SUMMARY INDEX
HISTORIC DISTRICTS REVIEW BOARD
 August 9, 2016

MINUTES OF THE
CITY OF SANTA FÉ
HISTORIC DISTRICTS REVIEW BOARD

August 9, 2016

SHEET NO.
 A-3.2

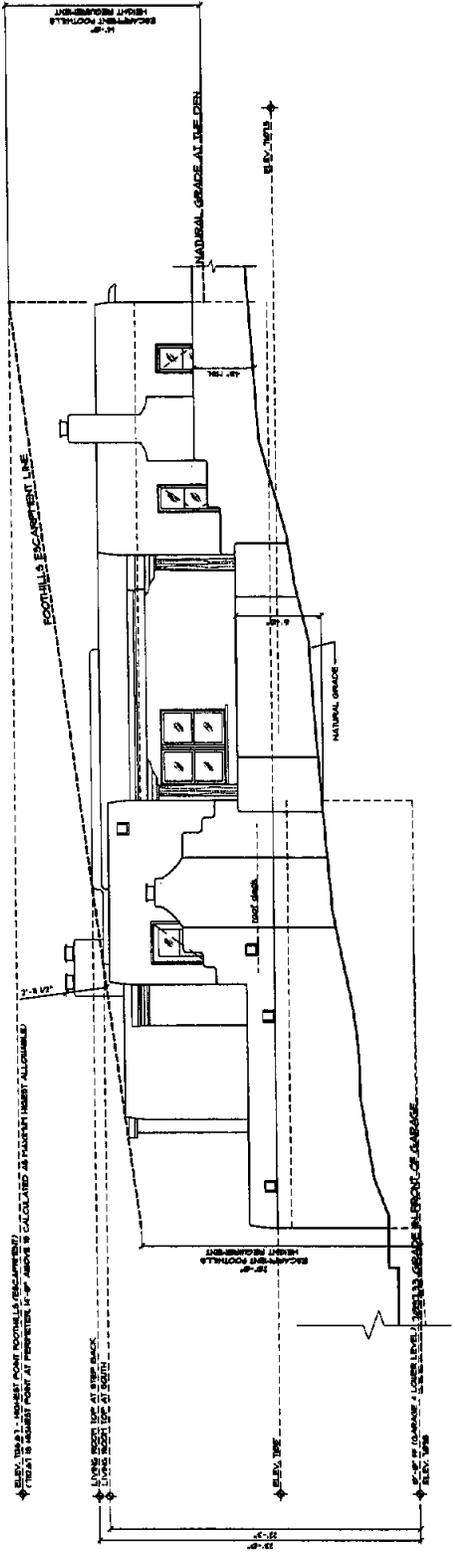
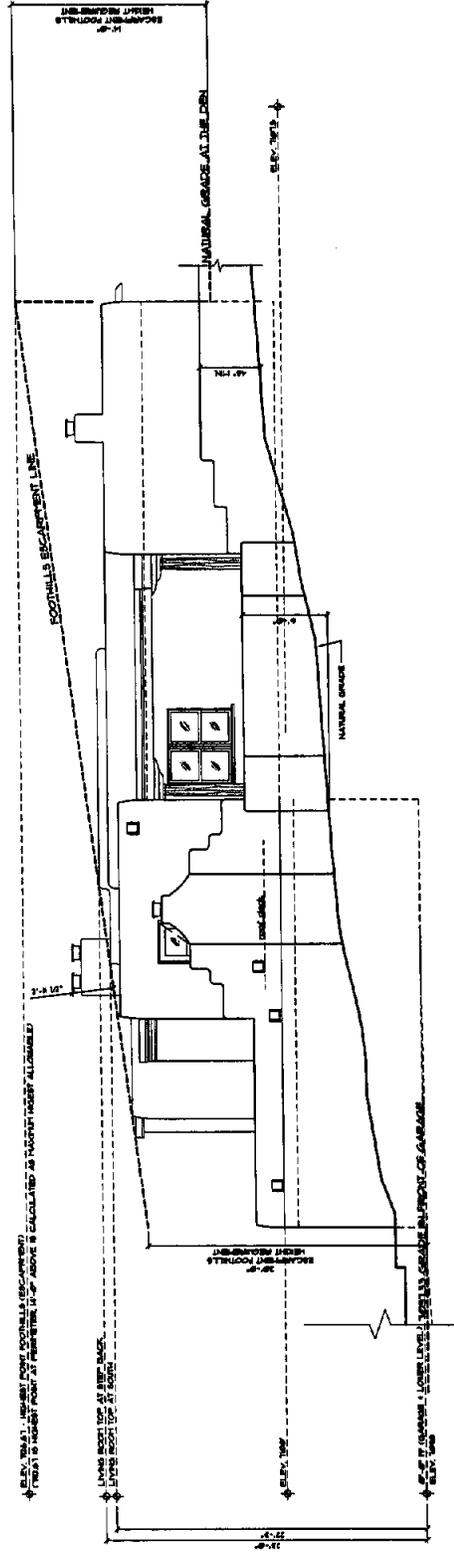
Mr. Enfield said on the south elevation, he added sidelights to the front door. He added a window to the right of the front door but removed the window that was further to the east and basically, moved a window to the west. He moved the southeast wall where the front door is located and to the east of the front door 30" and that is visible on the east elevation. He lowered the parapet above the entry by 3". The doors in the den changed to windows. The windows of the Master Bedroom moved 10" away from the corner so they are slightly closer to the center of the room. He changed the window in the basement office, located under a portal from 4' 8" wide to 9' 10" wide. On the east elevation, the front door moved 30", lowered parapet by 3", eliminated the truncated chimney on the east façade of the den, and eliminated the 2 windows on the east side of the den. He shortened the master bedroom window from five to six feet tall.

Ms. Sayeda said she would be okay with everything except on south elevation under the portal. That change might not meet the 40% glazing rule. Perhaps Staff can work with the applicant on that design at the lower portal.

Mr. Enfield did not feel the 40% glazing rule was valid under a portal. None of the storefronts on the plaza would be legal if that were applicable. His understanding was that the 40% is not for under portals but on flat visible façades. But he could eliminate that proposed change. The 4' 8" is about 40%. They asked to do a larger window and nowhere in the code does it say you can't have more under a portal.

1. Add Sidelights to front door.
2. Add new window to right of front door and remove window further to the east.
3. Move Southeast wall where front door is located and to the east of the front door out 30". (This revision is visible on the east elevation.)
4. Lower Parapet above entry 3".
5. Doors in den to be changed to windows. (Slightly visible in back of entry block, just to the right.)
6. Windows at master bedroom moved 10" away from corner so slightly closer to center of room.
7. Change window in basement office, which is located under a portal, from 4'-8" wide to 9'-10" wide.

A-4.1

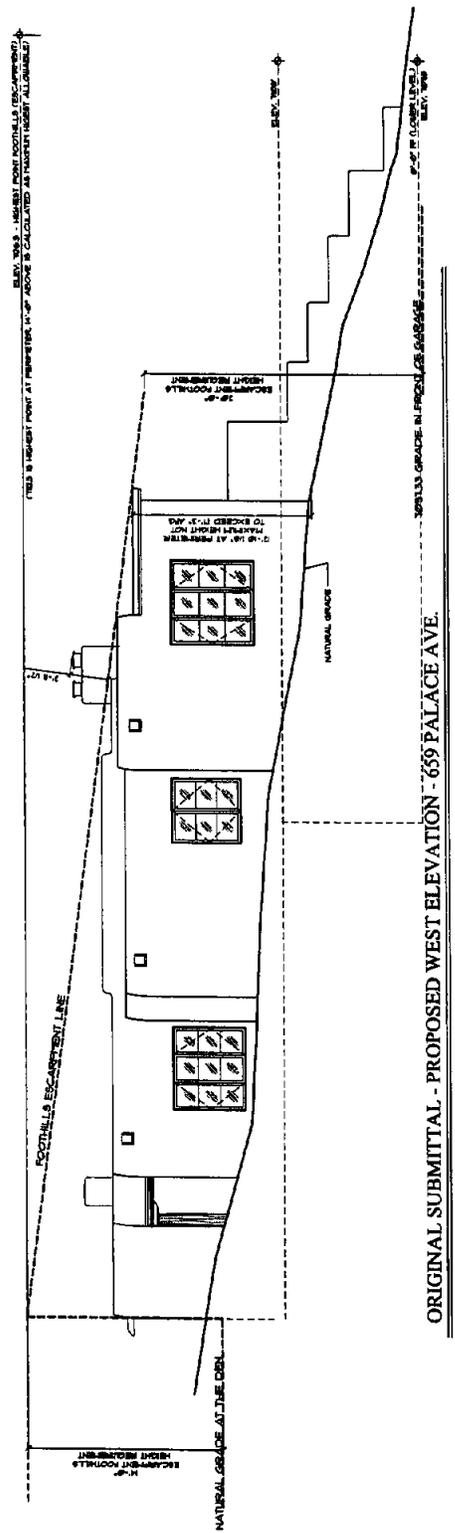
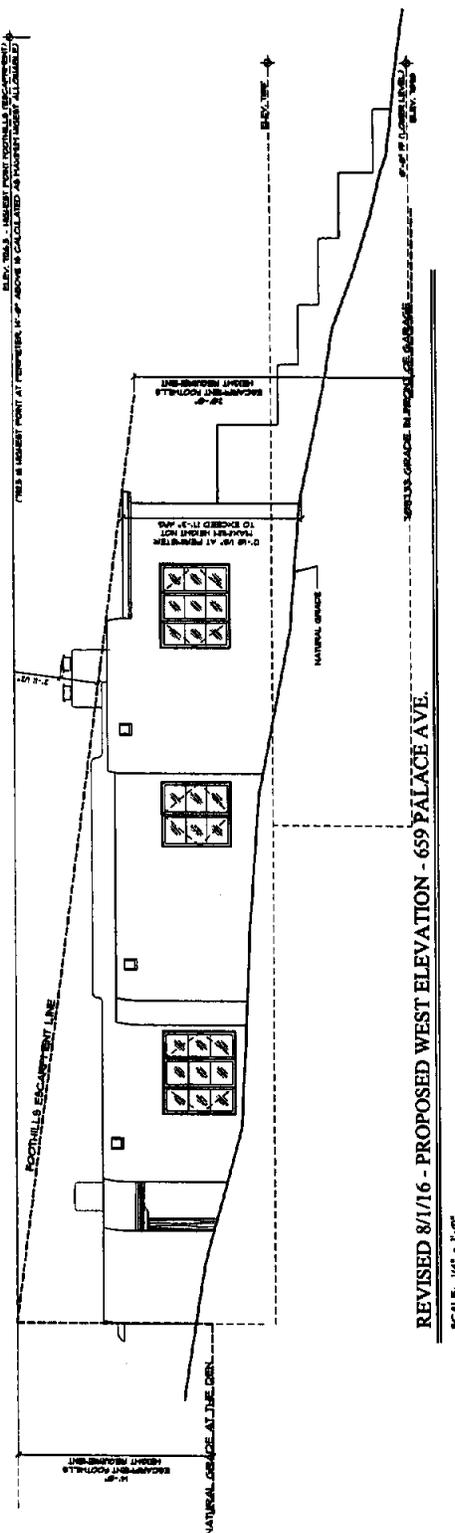
Mr. Enfield said he had it under 40% but his client asked for a larger window. A good place to see the grade is the west elevation. You can see the natural grade and the final grade and see how it works with the structure. The dotted lines show the basement under the house. It is underground on three sides.
